DRAINAGE PLAN WILLIAMSBURG ADDITION

PROJECT: WILLIAMSBURG STORM SEWER SYSTEM 100

SUBJECT: Williamsburg Residential C.U.P.

PROJECT NO. 32-84541-2, 3, 4-02
PROJECT: Williamsburg Addn -
Streets, Storm Sewer & Storm
Drain
DATE: January 9, 1985

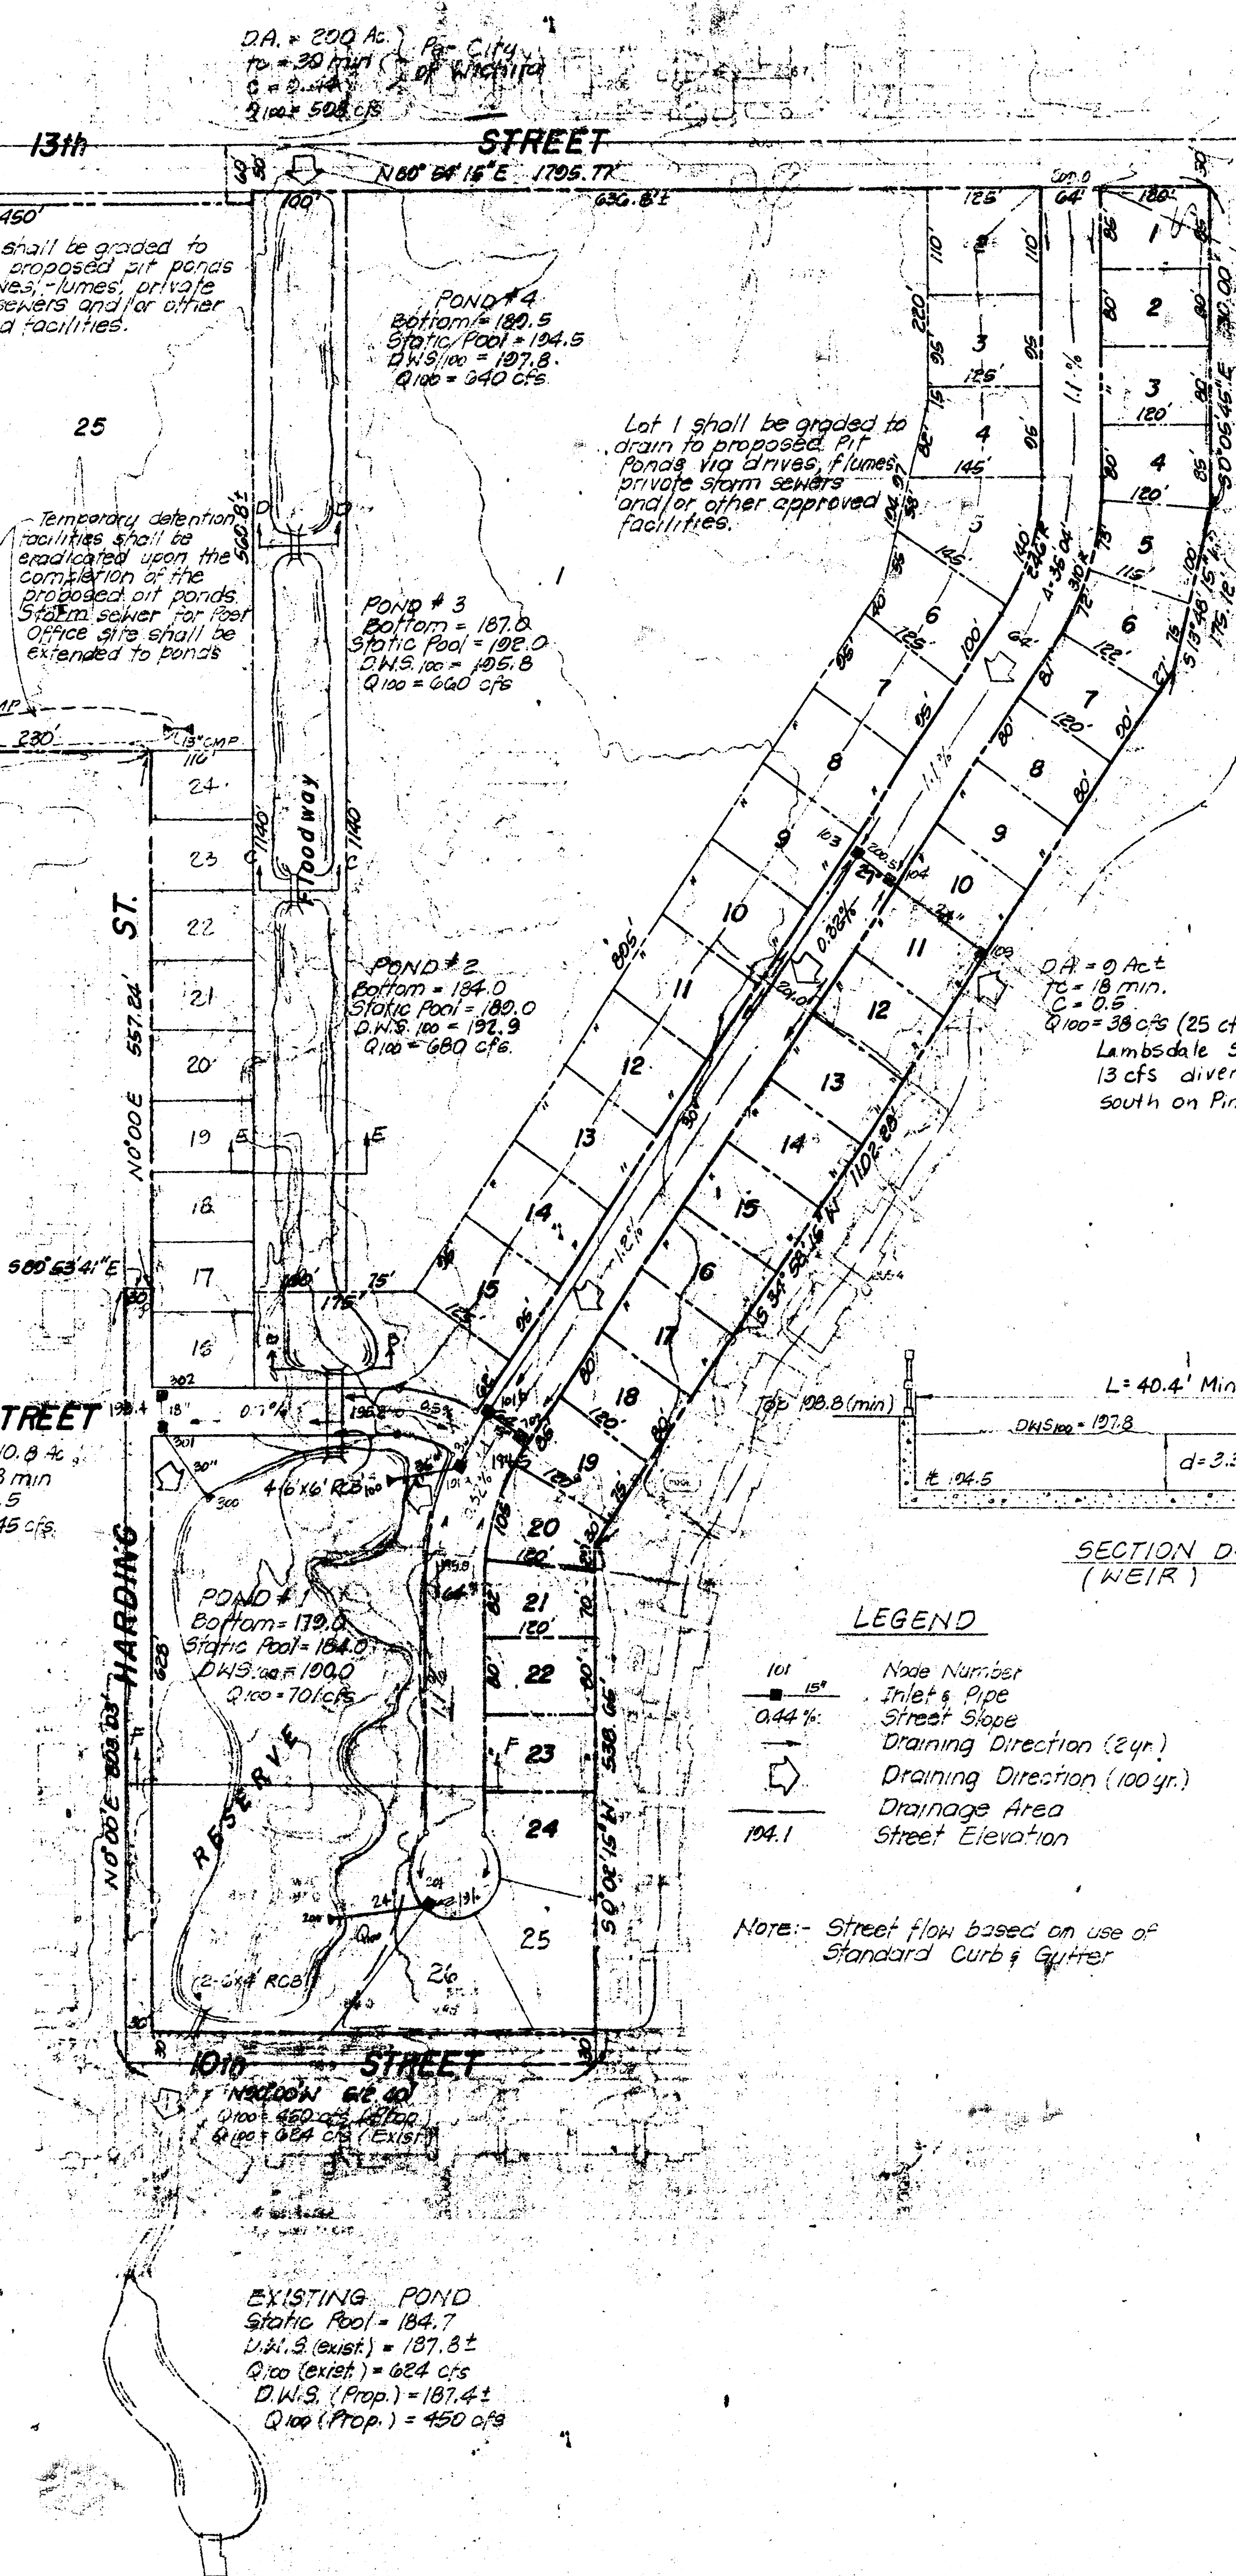
Revised 10-18-84: a) Lowered Pond No. 1 Elev.
 b) Added 11th St. from St. Sewers
 c) Decreased Q₁₀₀ from Lambdale St.
 d) Widened Weirs

Revised 7-19-84 (Lambdale St Drainage) C&B

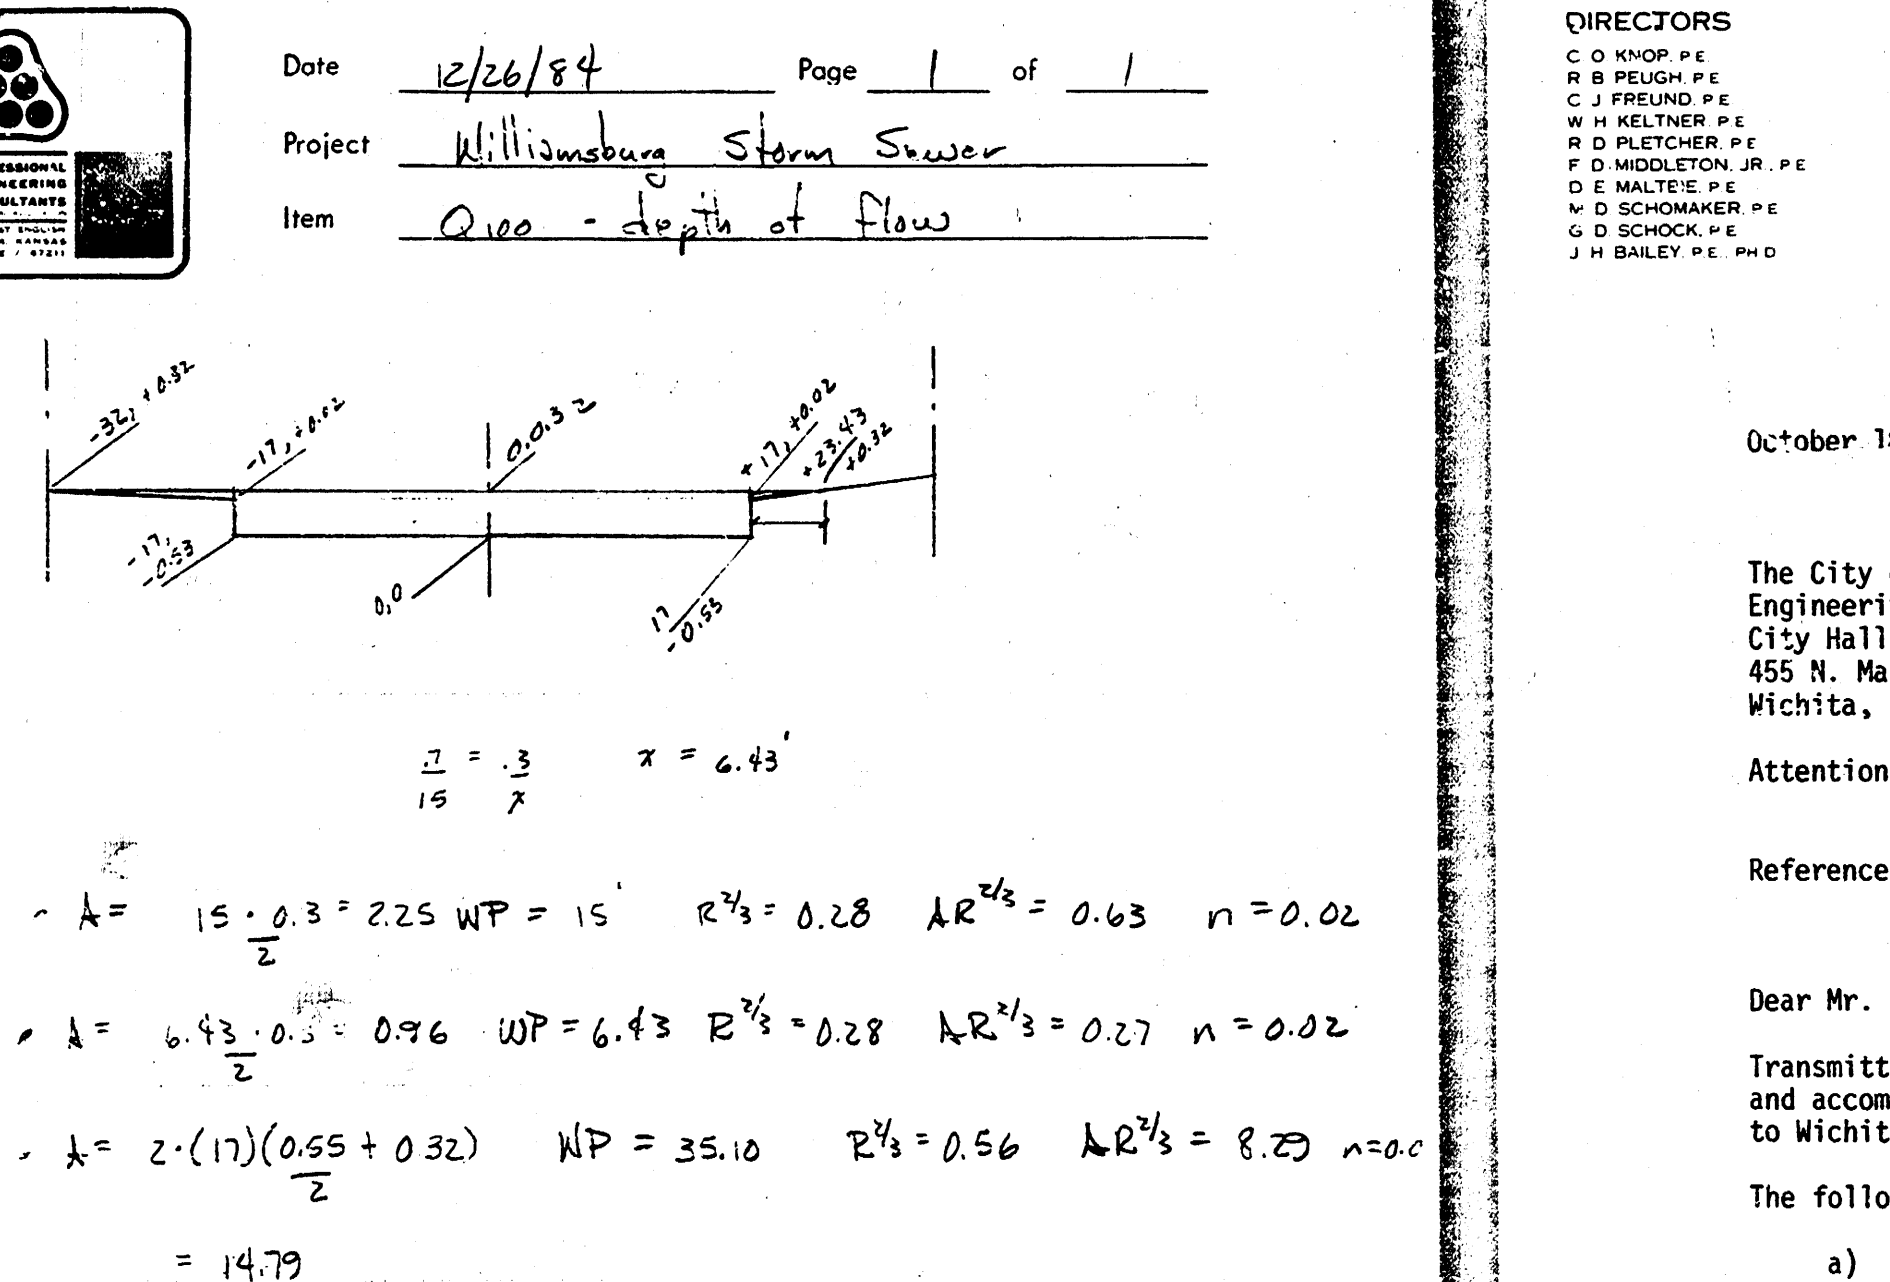
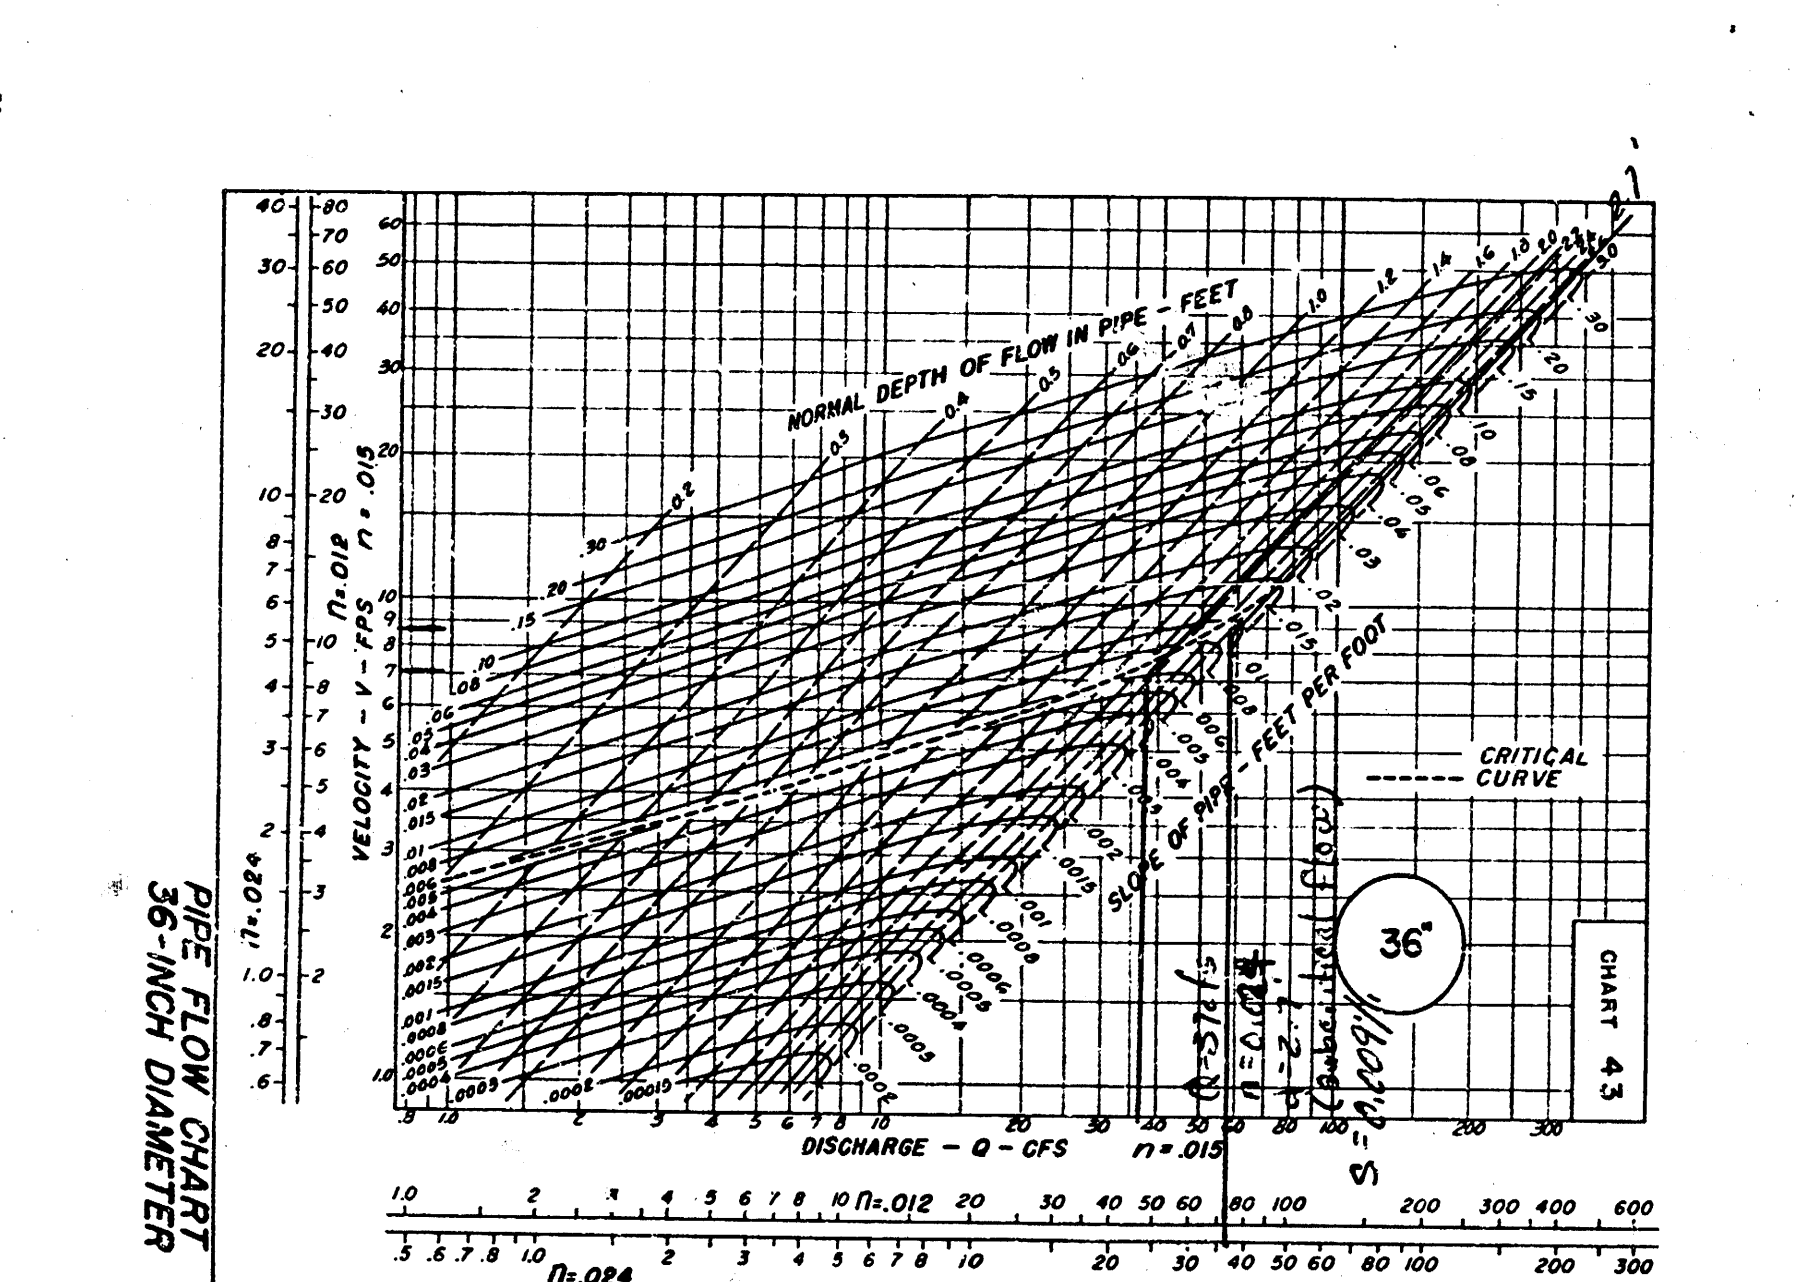
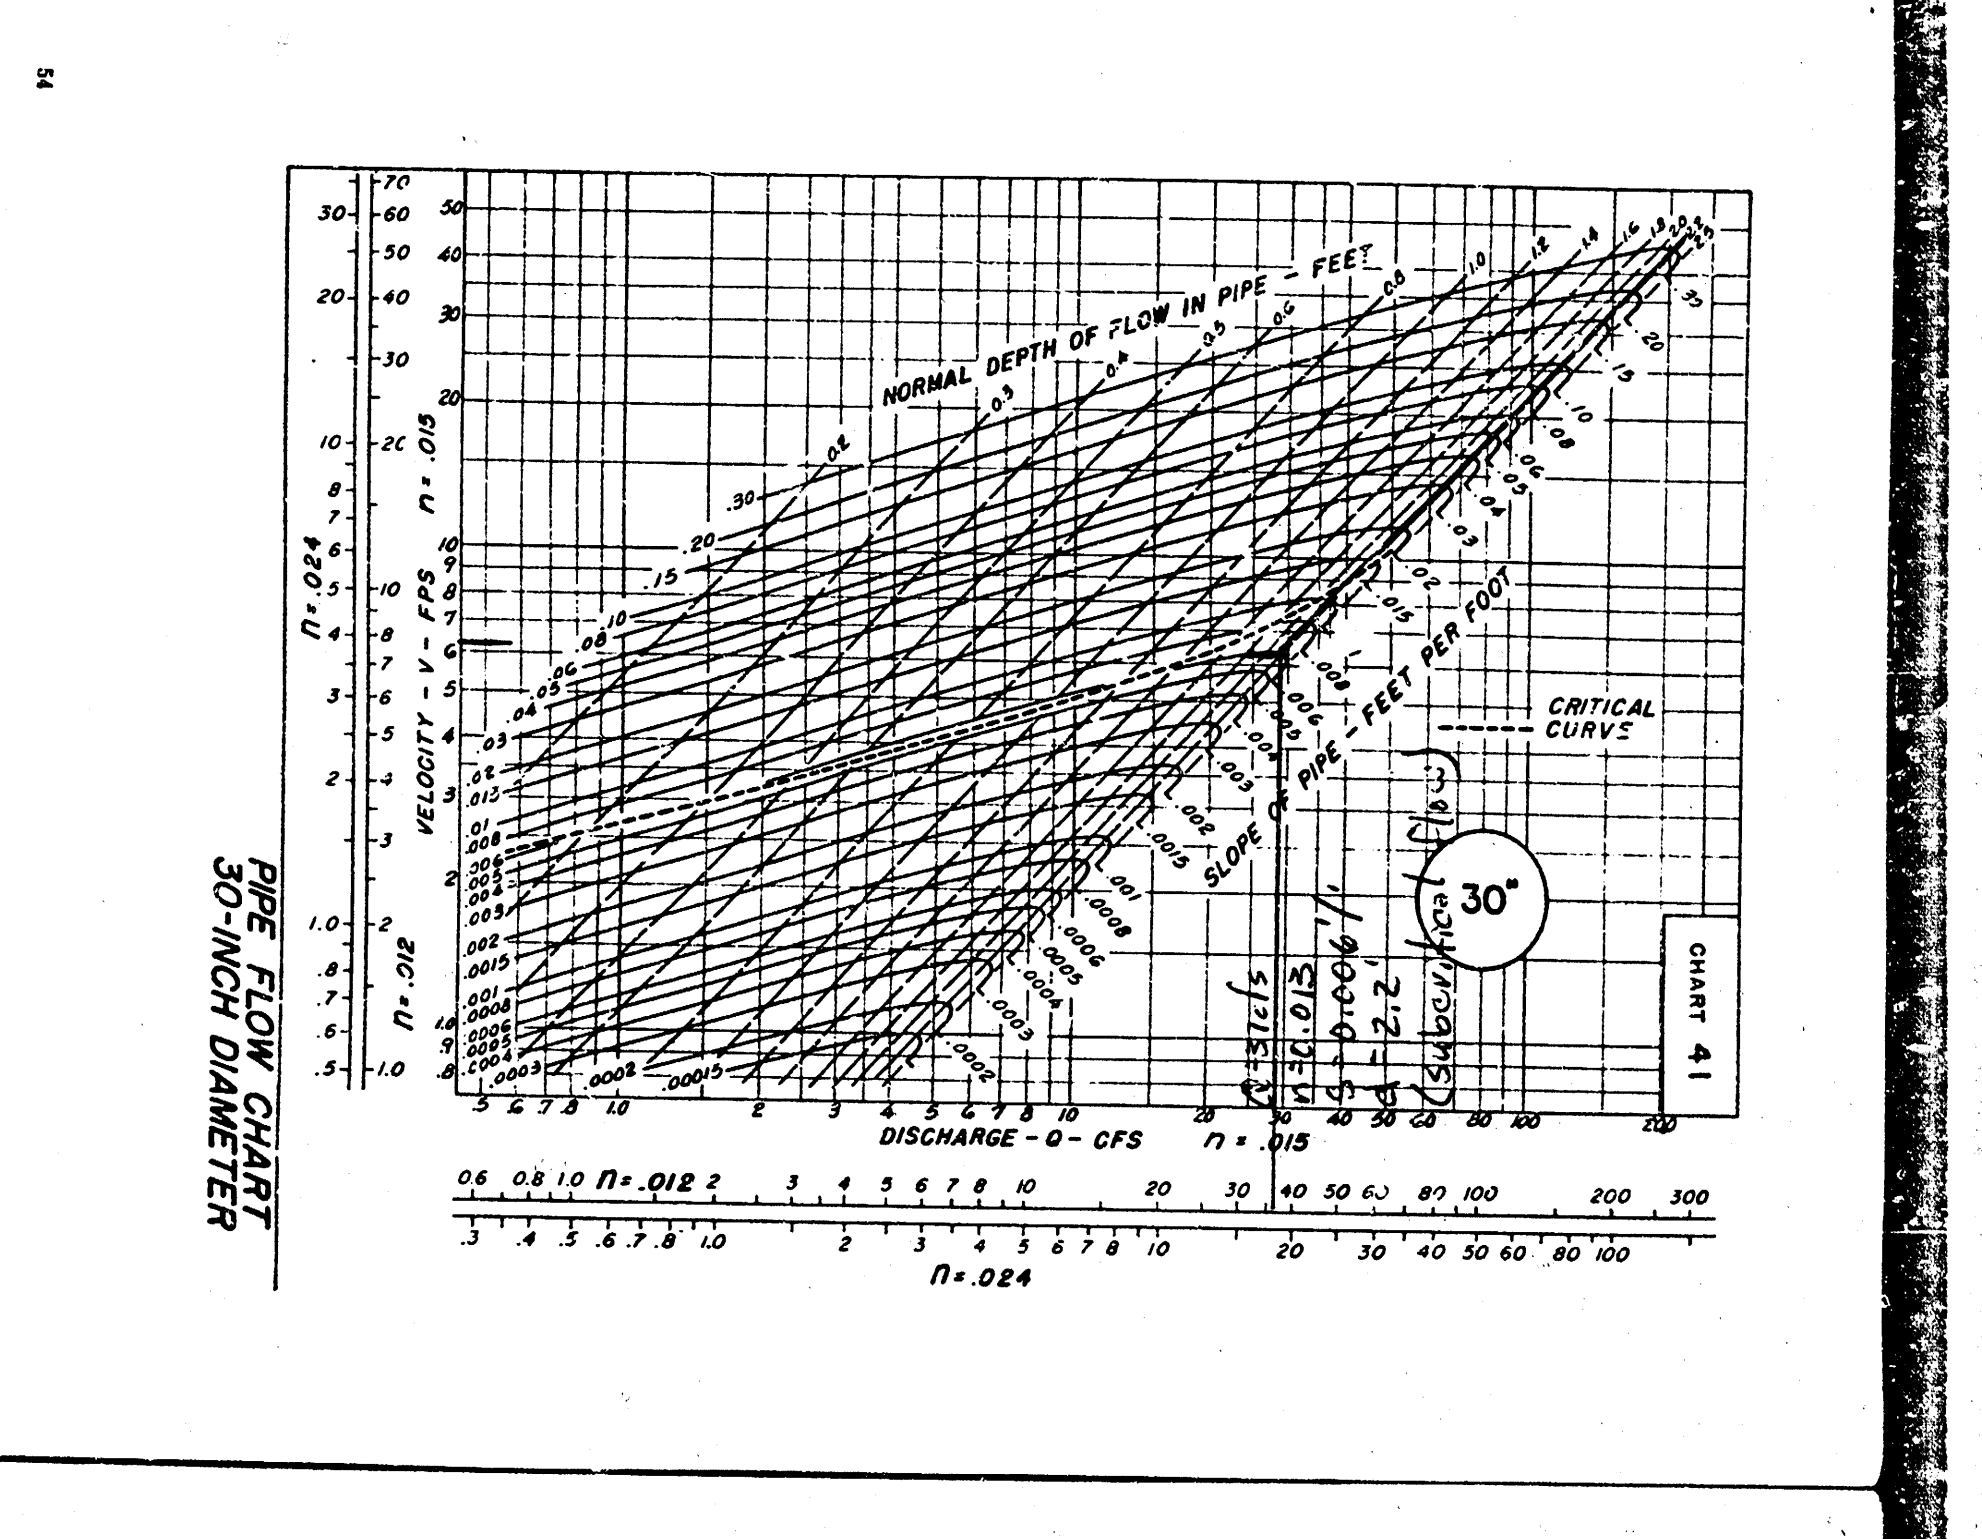
The required length of the weirs used as control structures for Pond No's 2, 3, and 4 have been increased. The increase in length will balance the decrease in efficiency due to the weirs being submerged. Increases range from 1.2 to 5.4 feet.
